B109 USO
Fort Moore

Open Stair behind Reception 101:

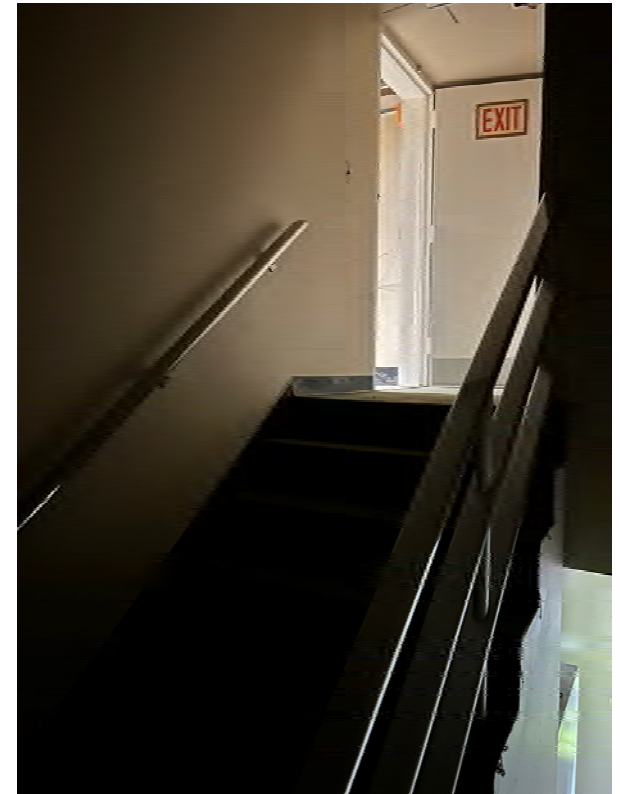
1. The handrails and knee wall are below the min. required height.

Stair 160:

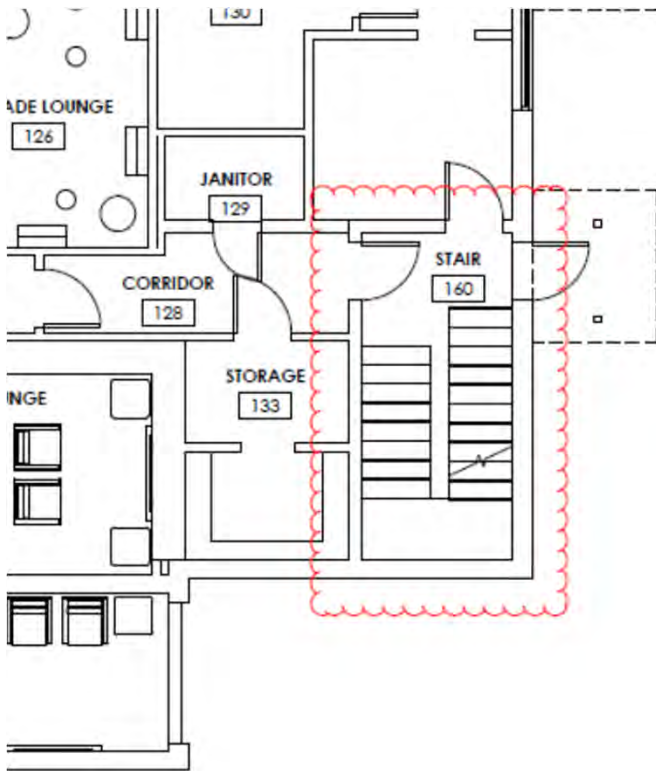
1. Handrailing below the min. requirements for the overall design.
2. Neither of the entry/exit doors are labeled as fire rated.

Stair 150:

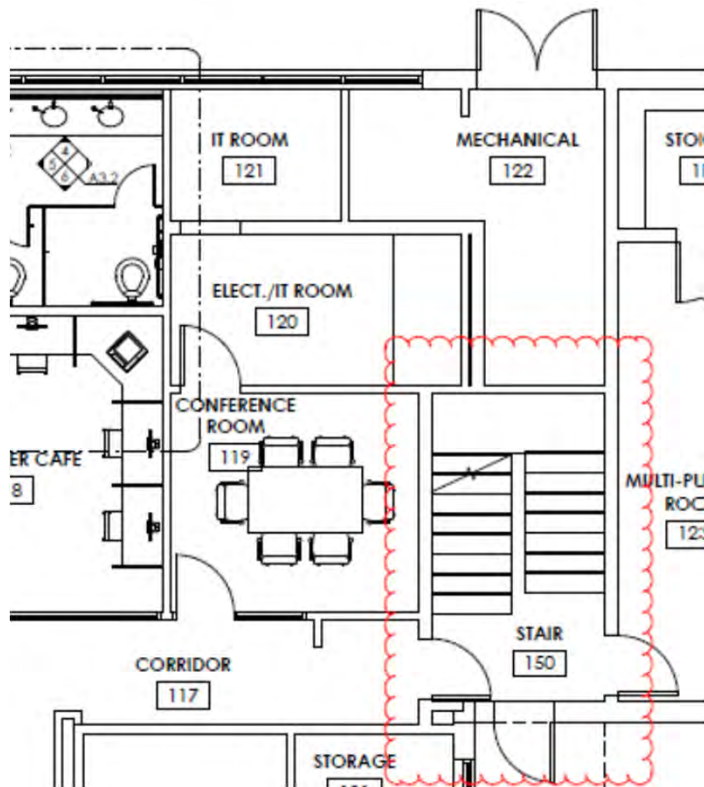
1. Width of stairs are less than 36" wide
2. Handrailing below the min. required height and open guards exceed 4" allowing a 4-inch sphere to pass through.
3. A built-in custom wood cabinet was installed on the landing of the stair years ago. The landing dimensions are not compliant.
4. The top riser is 10" and the bottom riser is 3".
5. The stairwell is not fully rated 1 hour:
 - a. Neither of the entry/exit doors are labeled as fire rated. One door is wood with a vision panel at second floor.
 - b. The CMU walls do not extend to the underside of the roof decking.
